Response to Reviewer 1

Response to Reviewer 2

Figure 1: downstream area of each upper Indus sub-basin, including those areas connected through linkage channels.

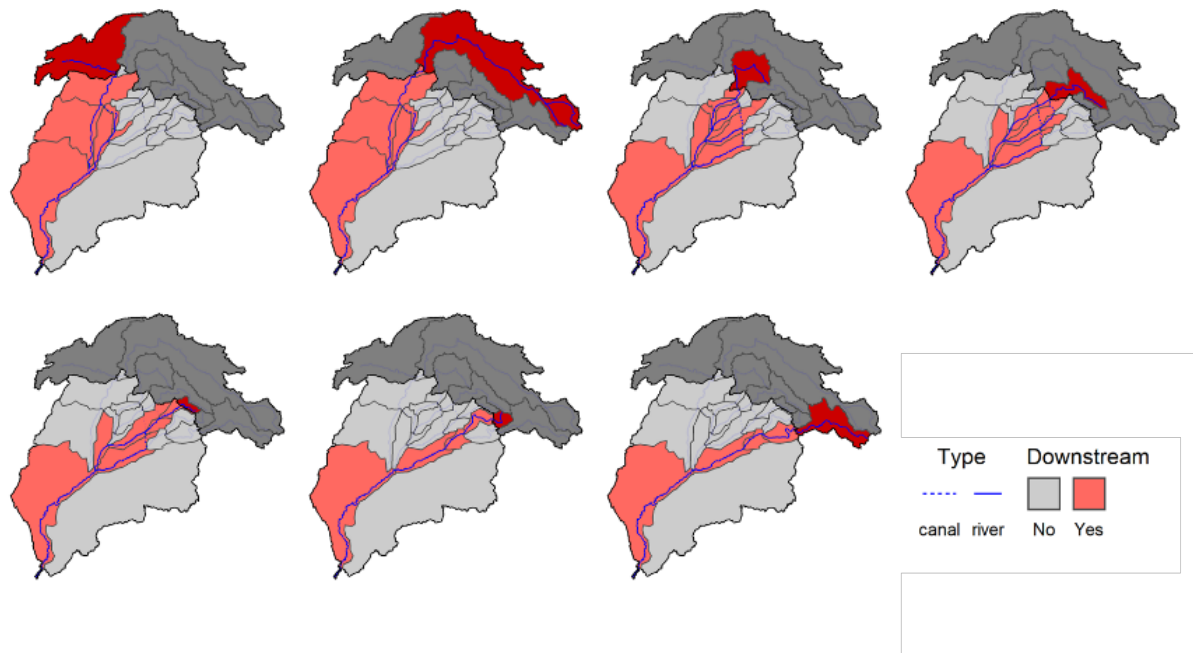
2.) The authors claimed that their novelty is to reveal the effect of upstream water consumption in the Indus water availability under climate change and population growth. However, it is not clear if they have any other innovation in their approach compared to general research in transboundary rivers.

- To obtain these outcomes, we developed a simple yet novel approach for quantifying upstream-downstream linkages in complex transboundary basins with variable water flow directions. The aforementioned (global) studies that quantify upstream-downstream dependencies relied on frameworks that assume that each basin consists of two or three coarse sub-basins with a linear connection based on natural flow direction. However, in reality, the spatial allocation of upper Indus water over downstream areas is highly controllable, due to an expansive network of barrages and linkage channels (Wescoat Jr et al., 2018). This infrastructure allows riparian states to optimally distribute the water of the Indus tributaries allotted to them by the Indus Water Treaty (see Basharat, 2019). The availability of upstream water to downstream sub-basins is hence variable, and this non-linearity cannot be simulated with fixed natural flow approaches used in previous studies. Our new approach therefore determines water availability directly on a per-capita basis by allocating surplus water resources of upstream sub-basins equitably over all their downstream inhabitants, including those in areas connected through linkage channels (see figure 2 in the manuscript). This allows us to jointly assess multiple upper Indus sub-basins with overlapping and converging downstream areas (see

Figure 1 of the response), even if those areas are shared by multiple riparian states, and without having to make quantitative assumptions as to how water is shared between competing sub-basins. Additionally, the effects of downstream population changes, both in total amounts and in spatial distribution, on transboundary upstream-downstream dependencies can be assessed using a transparent approach, which is explored in Figure 7 of the manuscript. As such, the approach developed in this study can also be used in other complex transboundary basins for high-resolution quantifications of upstream-downstream linkages as well as identify potential hotspots for water conflicts.
